Accession No. ML020840200Purpose of Meeting
(copy from meeting notice)**Discussion of the Framatome fuel transition program****at North Anna Power Station.**

North Anna Fuel Transition Program

Review Status Meeting

***NRC-One White Flint North
April 16, 2002***

FIGURE 1-24. TEMPERATURE RISE VRS. FLOODING RATE TO ROD PEAK POWER RATIO

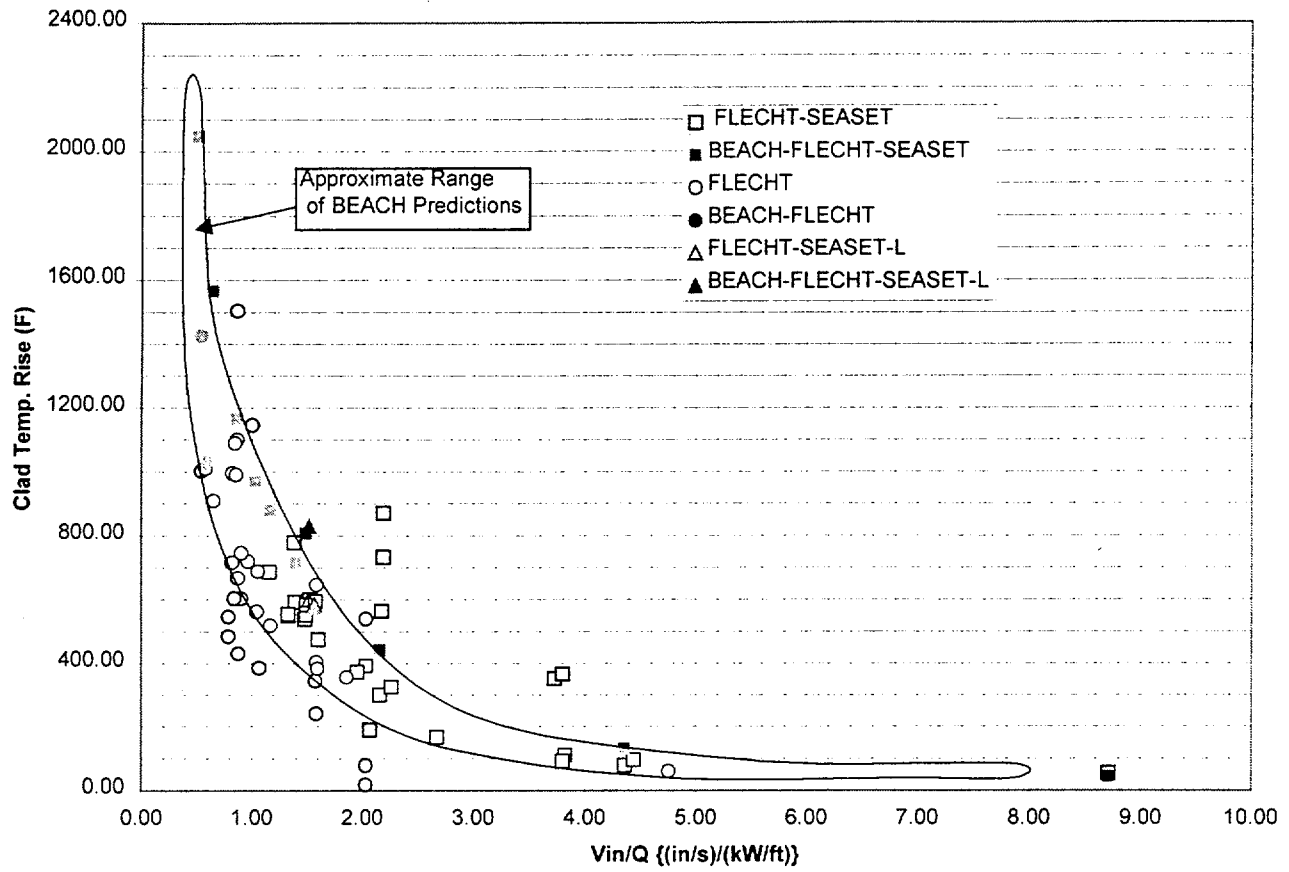
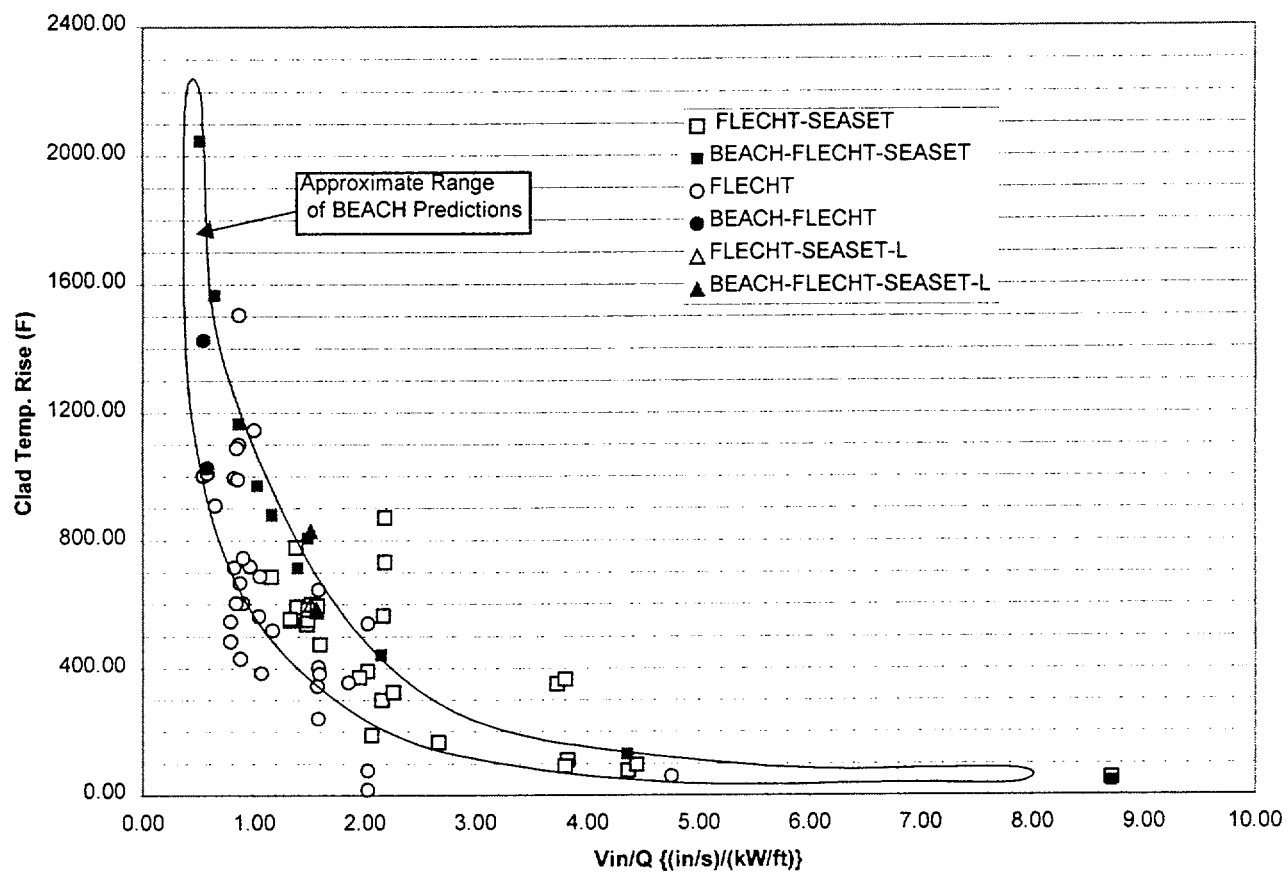
Relative to the quench front prediction for FLECHT Test 8037, Framatome ANP agrees that the benchmark of this test indicates an excessively quick decrease in cladding temperature. However, this test appears to be outside the norm in this regard. In the BEACH topical report, Question 1, the subjects of quench time and metal-water reaction were discussed; please refer to pages 5-291 through 5-302. Also note the Revision 4 SER and TER on pages 5-340 and 5-341, and 5-354 and 5-355, respectively, where the effects of the earlier higher temperatures and the cladding gap are credited as trading off against the slightly earlier BEACH quench prediction.

FIGURE I-15 FLECHT 3215B (15x15) BENCHMARK f3215v25.in 32-5014735-00

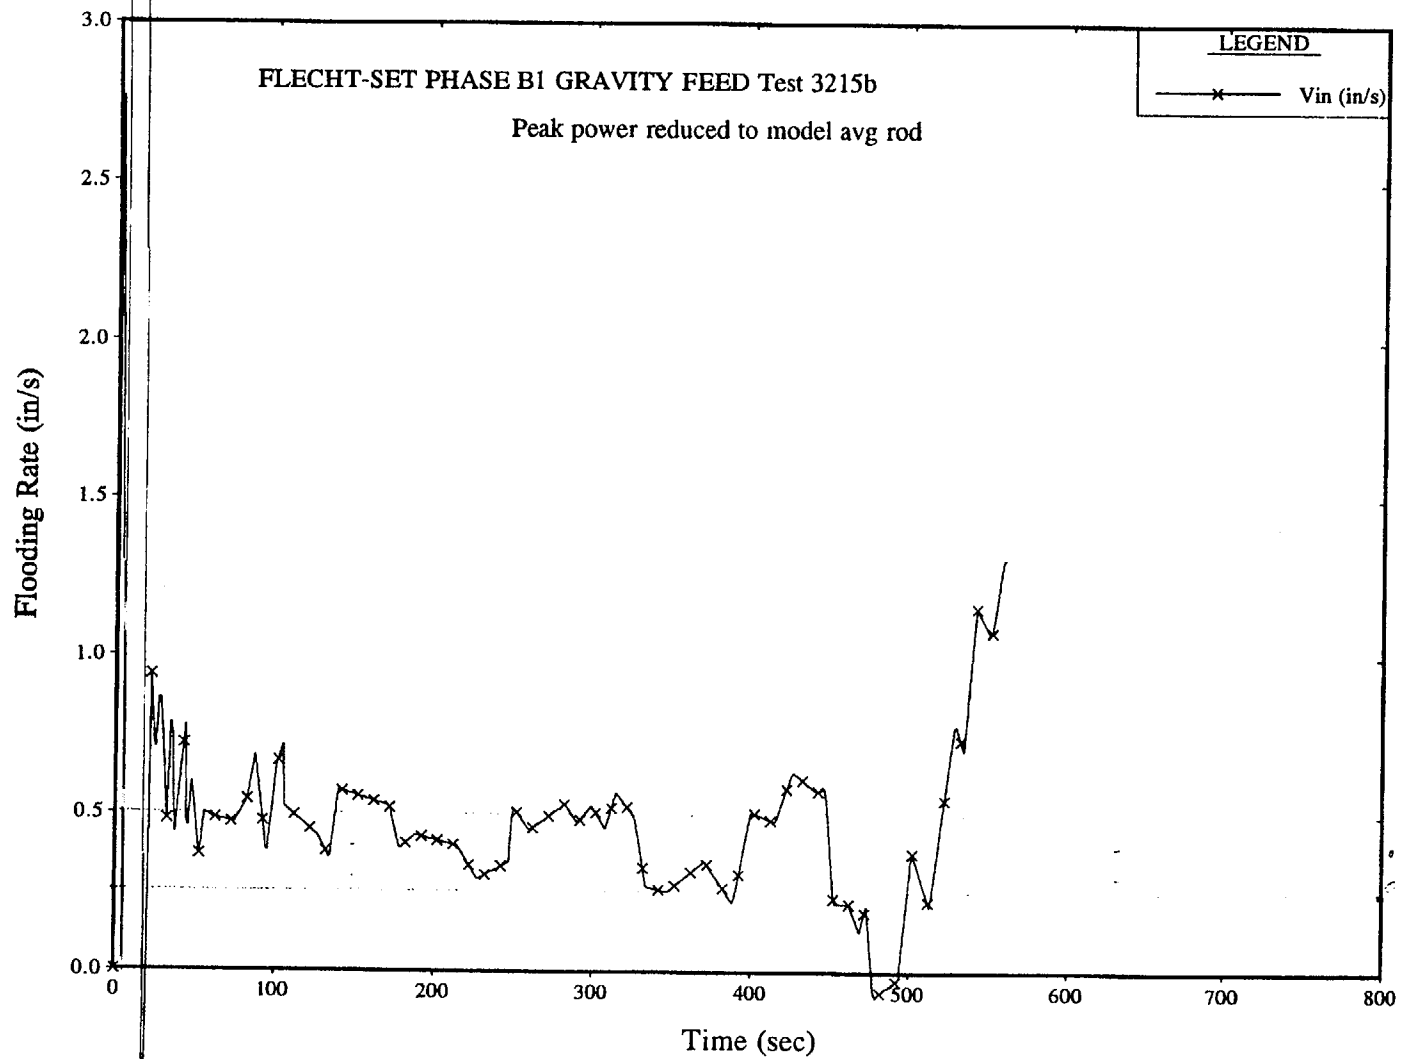
Enlarged copies of figures I-15 and I-17 were requested; they are attached hereto. These two figures are actual copies of the original digitized test benchmarks, rather than just enlargements of the Appendix I figures. For ease of reference, these figures are labeled with the same Appendix I figure numbers. The third and fourth figures attached hereto are two different versions of Figure I-24. One with and one without shading within the envelope. The data points beneath the envelope should be visible in either figure.
